UNITED STATES PATENT AND TRADEMARK OFFICE

APPLICATION NO.	FILING DATE	FIRST NAMED INVENTOR	ATTORNEY DOCKET NO.	CONFIRMATION NO.
10/576,246	09/27/2006	Henning Sirringhaus	Q94482	8834
23373	7590	05/31/2007		
SUGHRUE MION, PLLC 2100 PENNSYLVANIA AVENUE, N.W. SUITE 800 WASHINGTON, DC 20037			EXAMINER LEE, JAE	
			ART UNIT 2823	PAPER NUMBER
			MAIL DATE 05/31/2007	DELIVERY MODE PAPER

Office Action Summary

DETAILED ACTION

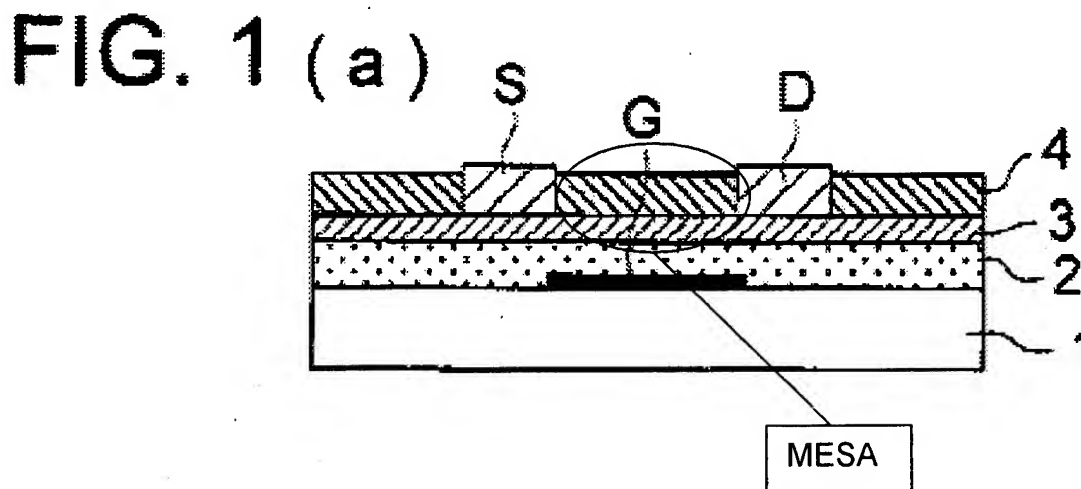
With regards to **claim 1**, Hirai et al. teaches a thin film transistor electronic switching device, comprising:

a source electrode and a drain electrode (see Fig. 1a, source **S** and drain **D**);

a semiconducting region in contact with and extending between the source and drain electrodes (see Fig. 1a, organic semiconductor layer **3**);

a gate electrode disposed for influencing the transconductance of at least part of the semiconducting region (see Fig. 1a, gate electrode **G**, inherent that the gate electrode will influence transconductance since drain current and the gate electrode voltage will change during operation of the device, $g_m = dI / dE$, where dI = change in drain current and dE = change in gate voltage); and

an insulating region located between the source and drain electrodes and configured so that the length of the shortest current path through the semiconducting region between the source and drain electrodes is greater than the shortest physical distance between the source and drain electrodes (see Fig. 1a, insulating region **4**, current path between **S** and **D** must be larger than the physical separation distance between **S** and **D**).

With regards to **claim 3**, Hirai et al. teaches a device as claimed in **claim 1**, wherein the shortest current path through the semiconducting region lies closer to the gate electrode than to all paths of the shortest physical distance between the source and drain electrodes (see Fig. 1a, current path between **S** and **D** will be closer to the gate electrode than the physical distance between any point of **S** and any point of **D**).

With regards to **claim 11**, Hirai et al. teaches a device as claimed in **claim 1**, wherein the source and drain electrodes make ohmic contact with the semiconducting region (see Fig. 1a, semiconducting region **3** in contact with source **S** and drain **D**).

With regards to **claim 14**, Hirai et al. teaches a device as claimed in **claim 1**, wherein said insulating region comprises a mesa structure of a dielectric material (see Fig. 1a, mesa formed).

With regards to **claim 16**, Hirai et al. teaches a device as claimed in **claim 1**, comprising a gate dielectric layer between the gate electrode and the semiconducting region (see Fig. 1a, gate dielectric layer **2**).

substrate, wherein the insulating material preferably deposits in the region between the source and drain electrodes, but not on top of the source-drain electrodes (see Fig. 1a, insulating region **4** between source **S** and drain **D** and not on top of the electrodes).

FIG. 5

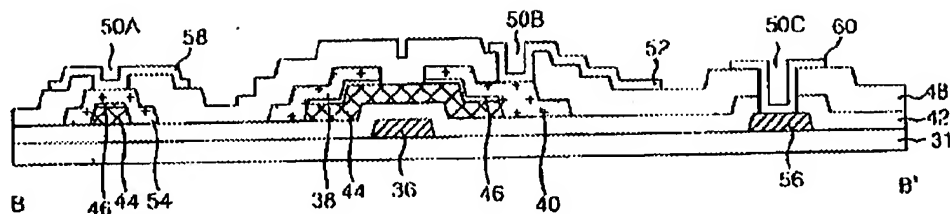
With regards to **claim 1** with dependent **claim 12**, Choi et al. teaches a thin film transistor electronic switching device, comprising:

a source electrode and a drain electrode (see Fig. 5, source electrode **38**, drain electrode **40**);

a semiconducting region in contact with and extending between the source and drain electrodes (see Fig. 5, semiconducting region **44**);

a gate electrode disposed for influencing the transconductance of at least part of the semiconducting region (see Fig. 5, gate electrode **36**; inherent that the gate electrode will influence transconductance since drain current and the gate electrode voltage will change during operation of the device, $g_m = dI / dE$, where dI = change in drain current and dE = change in gate voltage); and

an insulating region located between the source and drain electrodes and configured so that the length of the shortest current path through the semiconducting region between the source and drain electrodes is greater than the shortest physical distance between the source and drain electrodes (see Fig. 5, insulating region **48**,

current path from **38** to **40** shorter than the shortest physical distance between source electrode **38** and drain electrode **40**).
